## **MEMORANDUM**

**Subject:** **DESIGN RESPONSE CONFERENCE #12**  
**TOUCHSTONE (PARKPLACE)**  
**FILE DRC09-00002**

FIRST FLOOR PLAN, 12/07/09

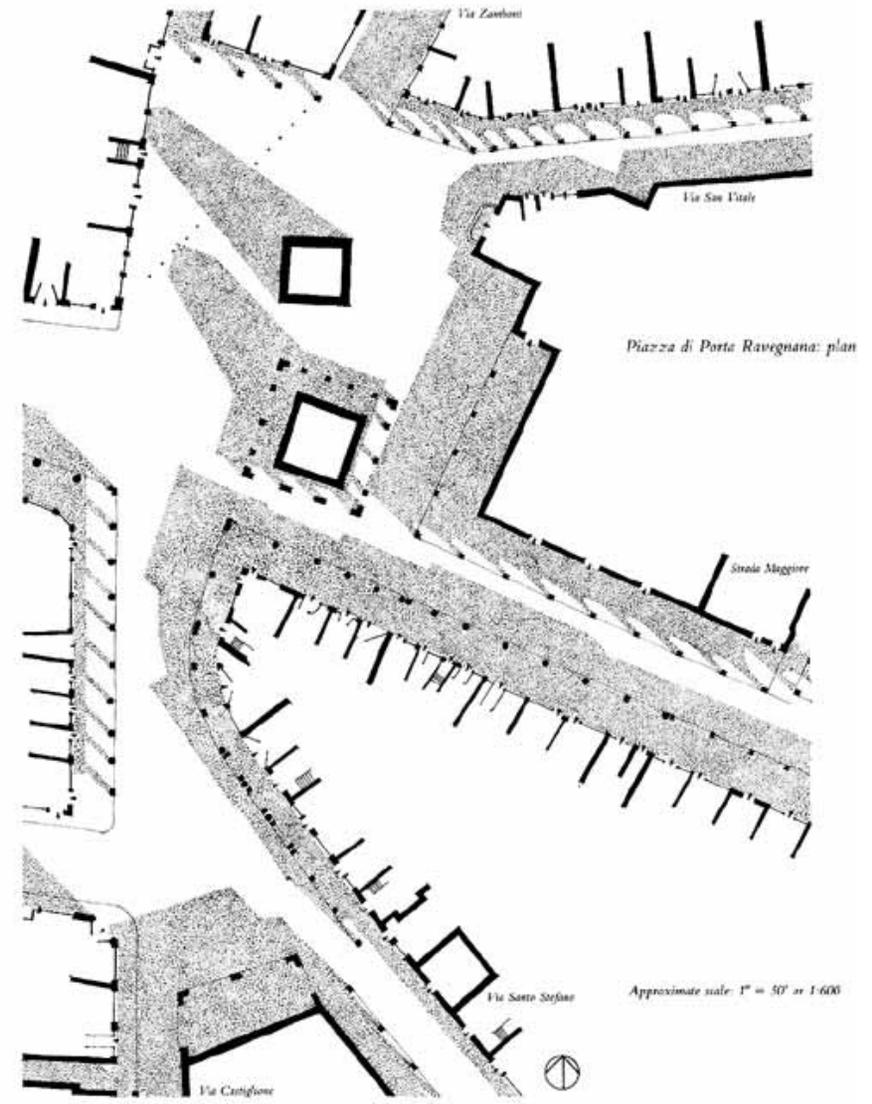
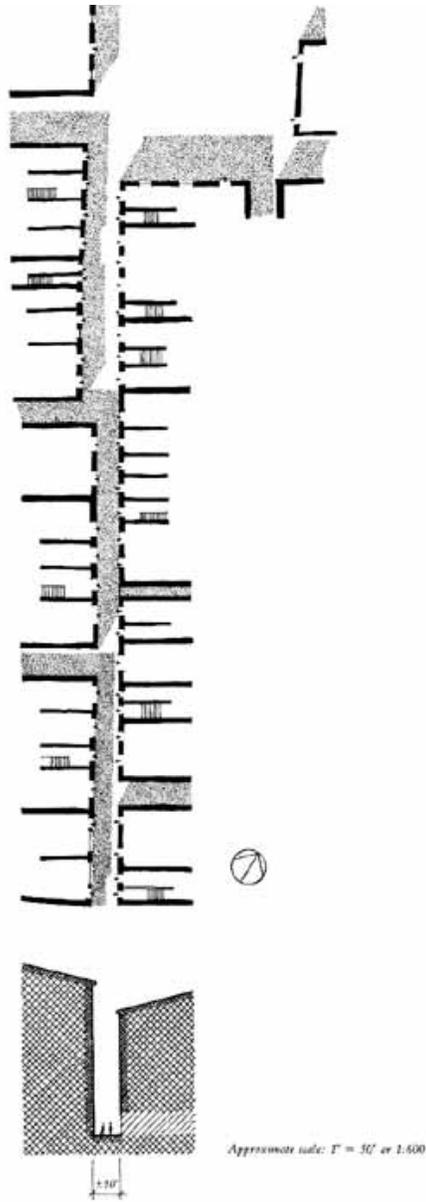
1. Space between Buildings 'B' and 'C':
  - a. Development Standards require 66' street width, while building faces are shown 49' apart. This creates deep cantilevers/colonnades and compromises the quality of the street experience. This needs to be resolved.
  - b. The portal to the site could be improved by raising the soffits at cantilevers and colonnade.
  - c. The massing of the buildings should open up to the plaza.
  - d. Measures should be taken to mitigate the vertical mass of the buildings.
  - e. A study of similar urban spaces would help the DRB to better visualize the proposed design.
2. South Elevation, Building 'C':
  - a. Massing concept approved pending facade articulation.
3. West Elevations:
  - a. The massing of the west elevation of Building 'B' should be broken up as suggested in design studies.
  - b. 'Gaskets' should be designed to optimize retail.

- a. The elimination of one traffic lane vs. the Design Guidelines requirement (4 lanes to 3 lanes) means that the total street width can be reduced to 60' with no loss of landscape or sidewalk. This eliminates the colonnade on Building 'B' and part of the cantilever on Building 'C'.
- b. The cantilever on Building 'C' has reduced in length from 120' to 90', and has been raised to the second floor soffit, about 30' above the ground.
- c. The cantilevered portion on Building 'C' narrows the space to 52', while the top floor of Building 'C' steps back to a width of 90' at the west end of the space.
- d. The north facade of Building 'C' has been broken up and stepped back to mitigate its height and provide a counterpoint to the verticality of Building 'B'.
- e. The design team will present a study of similar urban spaces to help the DRB to better visualize the proposed design.

FIRST FLOOR PLAN, 1/04/10

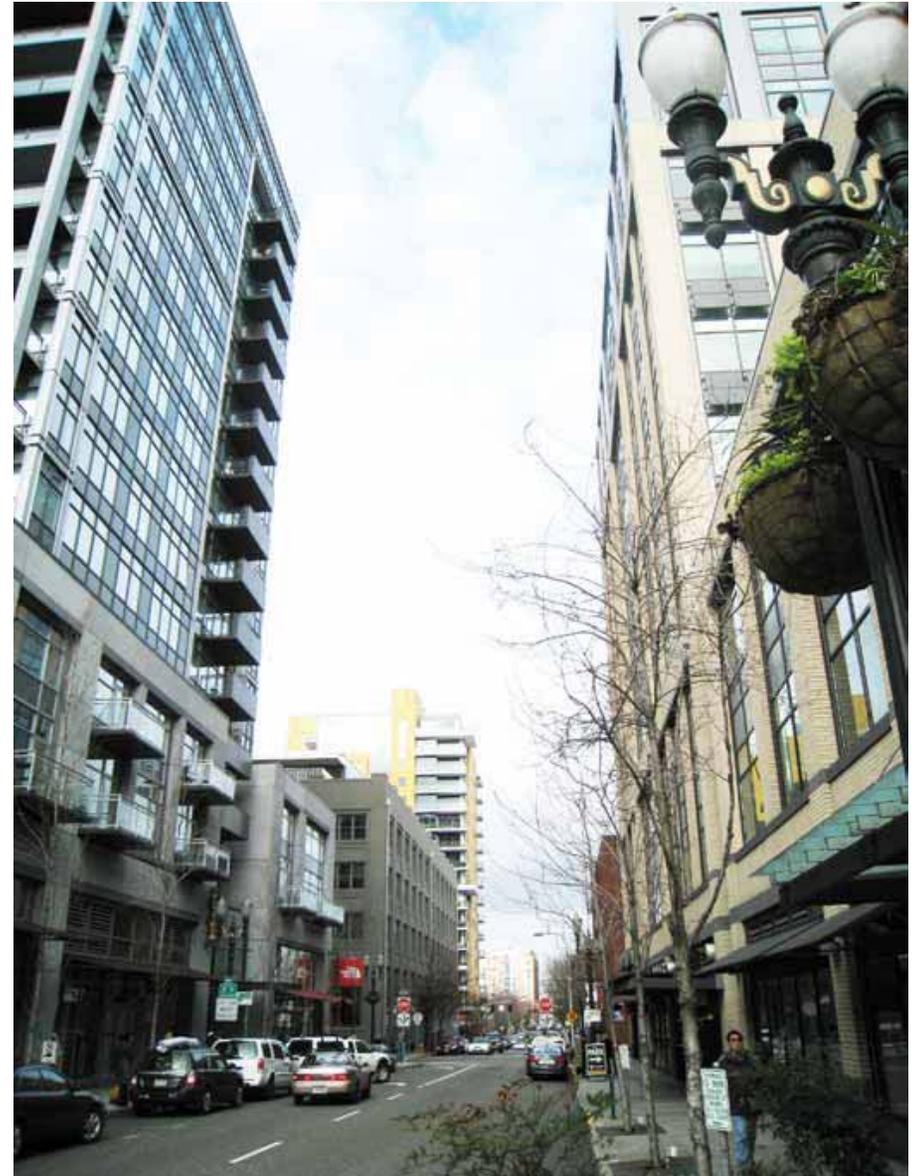
- Gaskets at Buildings A & B: The DRB approved of LMN's revised retail plan on Building C to pull the retail/gasket back along the north side of Building C; providing a greater opening between the buildings and plaza.

- a. The massing of the west elevation of Building 'B' has been broken up per the DRB's comment.
- b. 'Gaskets' and retail facades have been adjusted to provide more opening to the west.
